Regional Municipality of Waterloo

2021 General Conditions, Supplemental General Conditions, Standard Specifications, Standard Special Provisions and Standard Drawings for Unit Price Contracts

ADDENDUM NO. 1 – Issue Date: April 8, 2021

TRAFFIC FIBRE NETWORK SUPPLEMENTAL INFORMATION TO RWSS 18

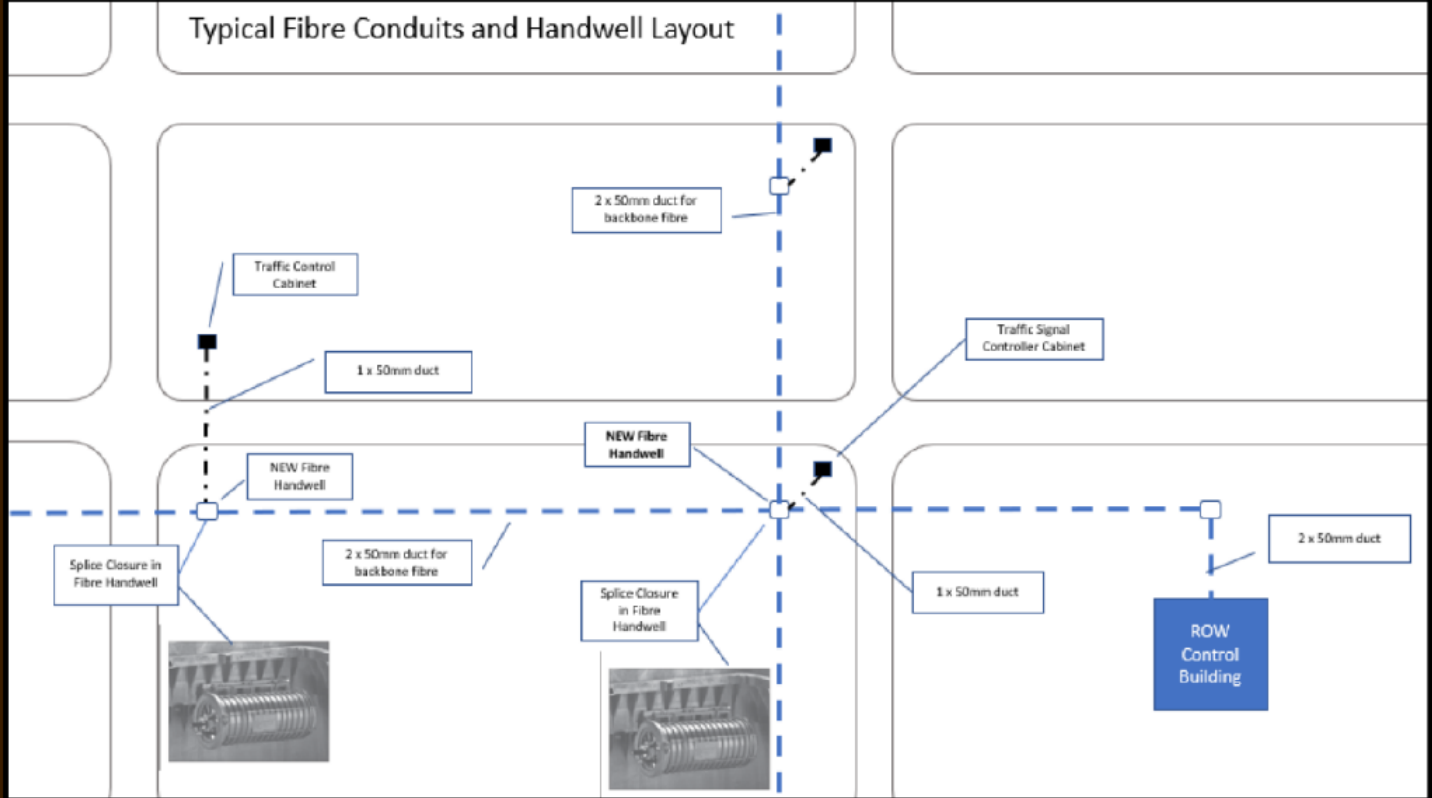
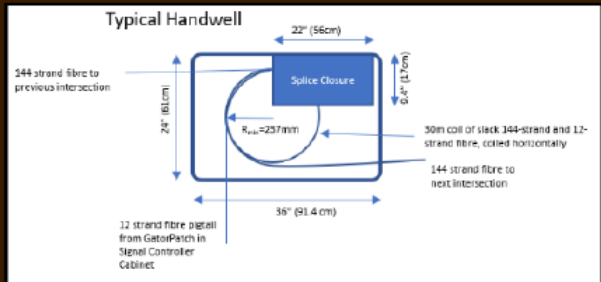
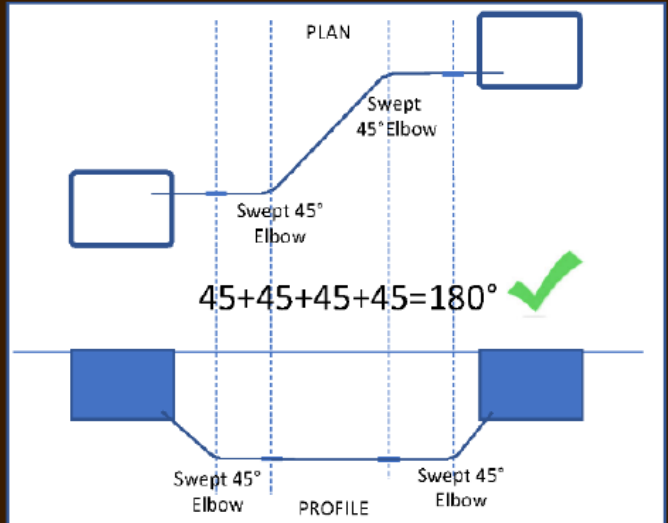
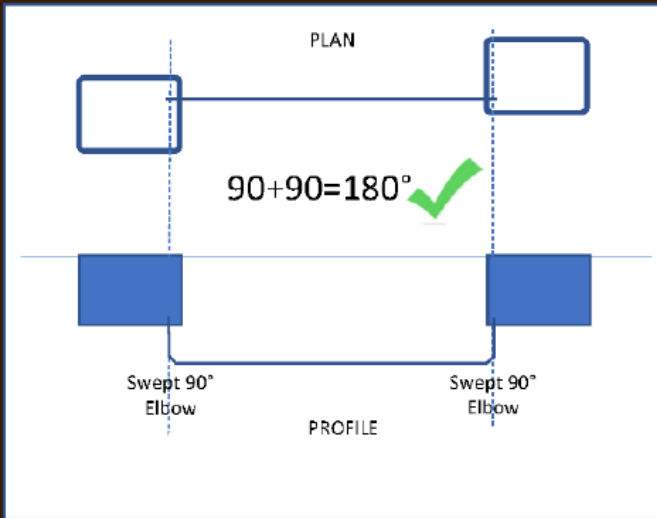
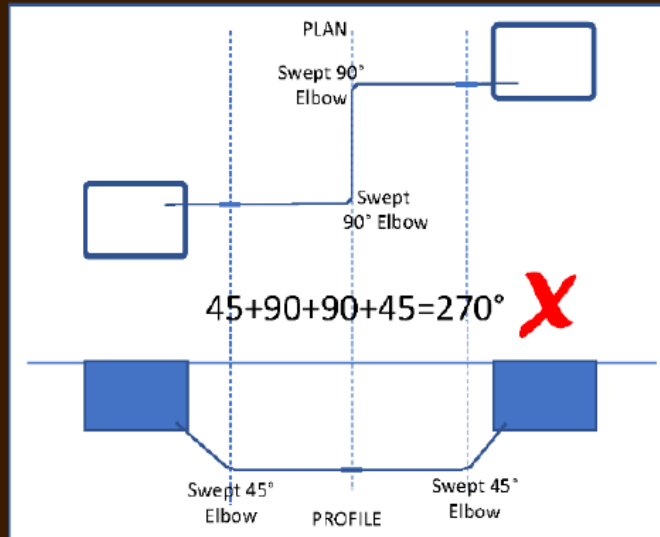
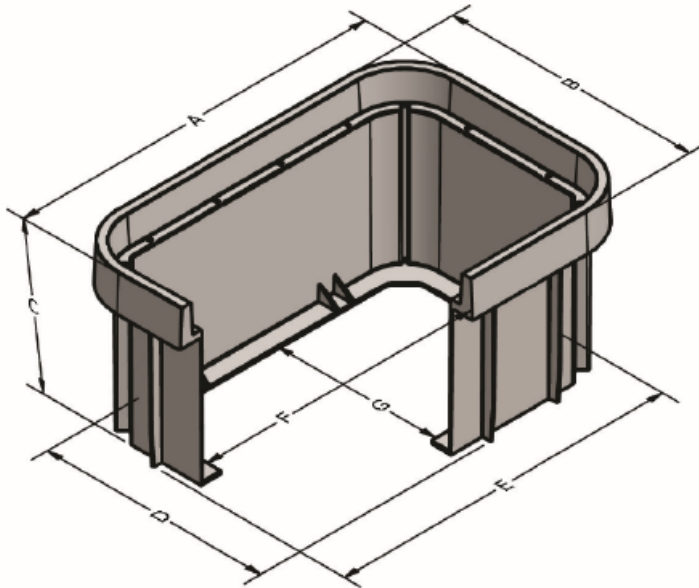
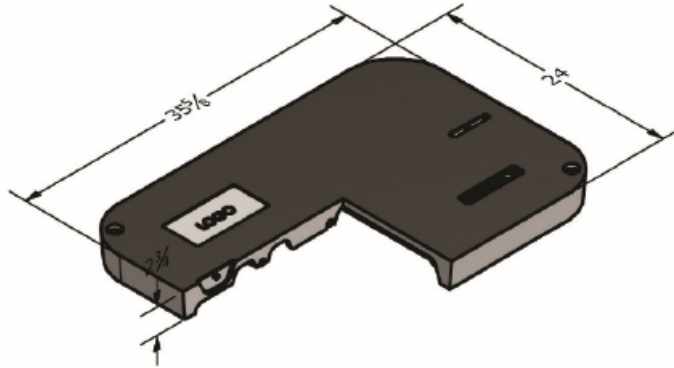
- The attached drawings are added to the end of RWSS 18.

The preferred spacing between two handwells shall be 350-450m. The spacing between the two handwells shall not be more than 500m.

Conduit/Duct Installation:
Maximum Bend=180°
(all directions)
